SUBJECT: DONALD C. COOK NUCLEAR PLANT, UNIT 2 - ISSUANCE OF AMENDMENT
TO REVISE TECHNICAL SPECIFICATION 3.3.2, ENGINEERED SAFETY
FEATURE ACTUATION SYSTEM INSTRUMENTATION (CAC NO. MF6984)

Amendment No. 313
License No. DPR-74

SAFETY EVALUATION BY THE OFFICE OF NUCLEAR REACTOR REGULATION

AMENDMENT NO. 313 TO RENEWED FACILITY OPERATING LICENSE NO. DPR-74

The LAR includes the following MFPT functional diagram:

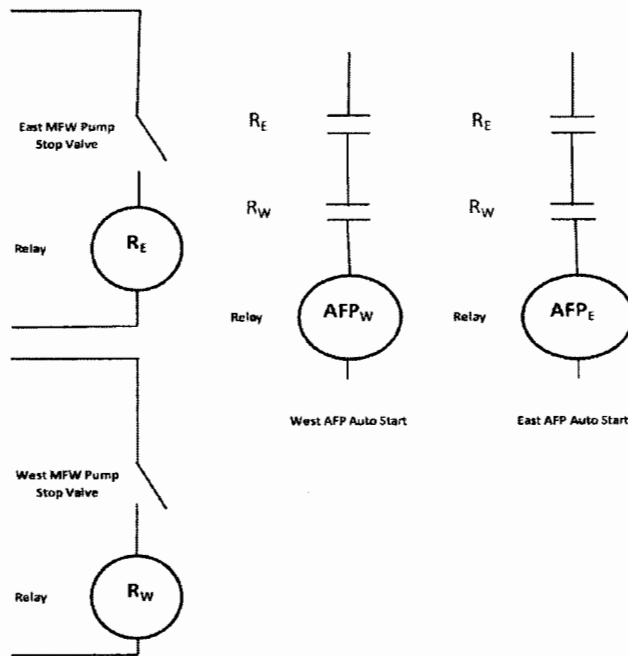
A MFW trip channel is considered to be the position indication switch, which closes when the associated MFW pump steam stop valve closes, along with the energization of the relay. The R_E and R_W relays for the MFW pump trip channels in CNP-2 provide input to the AFW pump actuation train logic. When the AFW actuation relay for either MFW pump (R_E or R_W) is energized, a signal is sent to the AFW pump actuation logic circuit. The AFW pumps will start when signals from both MFW pump channels have been received by the AFW pump actuation logic circuit.

The LCO requires one channel per pump to be operable. This function does not meet the single failure criteria, however this is acceptable since the SG water level low-low function is credited to start the AFW system in the analyses of design basis accidents and transients that result in a loss of MFW. Although a trip of all MFW pumps starts the motor-driven AFW pumps, the trip of all MFW pumps to initiate AFW is not credited in the CNP-2 safety analysis.
